Before the
FEDERAL COMMUNICATIONS COMMISSION
Washington, D.C. 20544

In the matter of)
)
Revision of Part 15 of the Commission's) ET Docket No. 98-153
Rules Regarding Ultra-Wideband)
Transmission Systems)

Comments on SIA Interference Study

Pulse~LINK Inc.

SIA report Figure 3 provided for reference

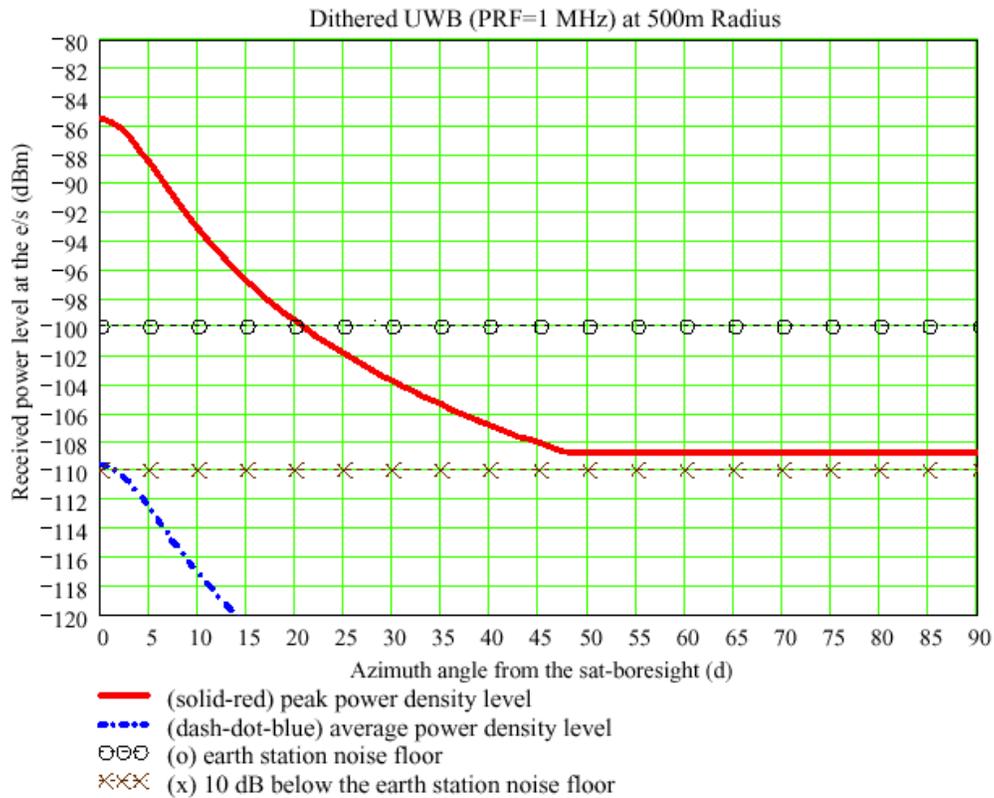
Figure 2 is inaccurate for UWB systems using techniques to reduce the peak-to-average power ratio. Additionally, for higher PRF systems the limiting factor is average power not peak power as discussed above.

Since high PRF systems are limited by average power, Figure 3 clearly demonstrates coexistence with earth ground stations for average power. SIA Figure3 is provided for reference, clearly showing the blue dashed line remaining below the noise floor of -100 dBm. The peak power density shown in the figure is indicative of a very low PRF without using any of the techniques previously discussed to reduce the peak-to-average power ratio.

This analysis would lead to the conclusion that a UWB device coexists with 51dB to spare. SIA's Figure 3 further supports this conclusion.
